Access Compliance Report

Public Rights-of-Way (Curb Ramps)

Intersection ID: 29600	Main Street: FOREST_POINT_BV	Cross Street: FOREST_PINE_DR	Location: SW
ADA ID: 901B66613913	Ramp Type: PerpDiag	Initial Pass/Fail: Fail	Overall Compliance: No
Severity Score: 22.5			
Codes/Mitigation Info/Possible Solution		Field Measurements/Component Compliance

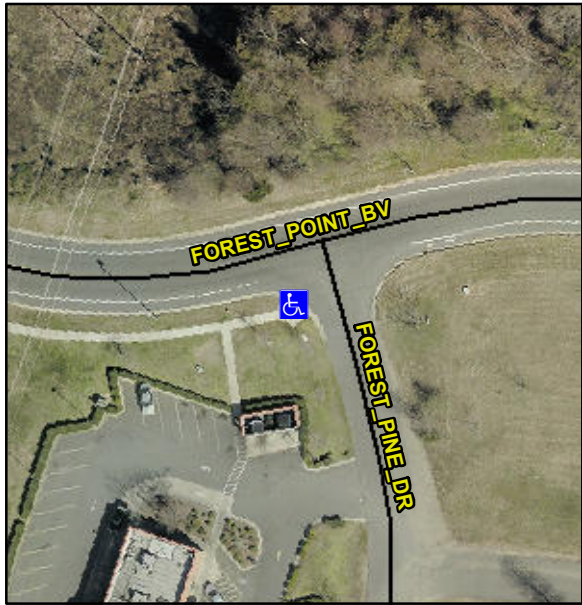
Not Found, R304.5.1, R304.2.2, R304.5.3

Compliance		Description	Data	Compliance		Description	Data
N/A		Ramp Length (in)	55.0	No		Ramp Slope (%)	9.1
No		Ramp Width (in)	46.5	No		Ramp XSlope (%)	3.5
N/A		Flare Type LT	N/A	N/A		Flare Type RT	N/A
N/A		Flare Slope LT (%)	N/A	N/A		Flare Slope RT (%)	N/A
N/A		Flare Traversable LT?	N/A	N/A		Flare Traversable RT?	N/A
N/A		Landing Length (in)	N/A	N/A		DWS Provided?	N/A
N/A		Landing Width (in)	N/A	N/A		DWS Contrast?	N/A
N/A		Landing Slope (%)	N/A	N/A		DWS Length (in)	N/A
N/A		Landing X Slope (%)	N/A	N/A		DWS Full Width?	N/A
N/A		Landing Curb? (Y/N)	N/A	N/A		DWS Offset (in)	N/A
N/A		Shared Landing?	N/A				
N/A		Gutter Ponding?	N/A	N/A		Gutter Slope (%)	N/A
N/A		Gutter Lip Ht (in)	N/A	N/A		Gutter X Slope (%)	N/A
N/A		Painted X Walk1?	No	N/A		Painted X Walk2?	No
		X Walk 1 Direction	To E			X Walk 2 Direction	To N
N/A		X Walk 1 Width (in)	N/A	N/A		X Walk 2 Width (in)	N/A
		X Walk 1 Slope (%)	3.4			X Walk 2 Slope (%)	2.0

X Walk 1 X Slope (%)	2.9			X Walk 2 X Slope (%)	3.4
N/A		Ramp inside XWalk1?	N/A	N/A		Ramp inside XWalk2?	N/A
		Road Slope (%)	0.9	N/A		Clear Space?	N/A
		Road X Slope (%)	4.3	N/A		Clear Space to XWalk (in)	N/A
N/A		Any Obstructions?	N/A	N/A		Storm Grate/Utility Hazard?	N/A
		Obstruction Type				Storm Grate/Utility Type	
			N/A				N/A
				Yes		Surface Condition? (G/P)	Good

Remove & Replace Curb Ramp With Two New Directional Ramps or Equivalent.
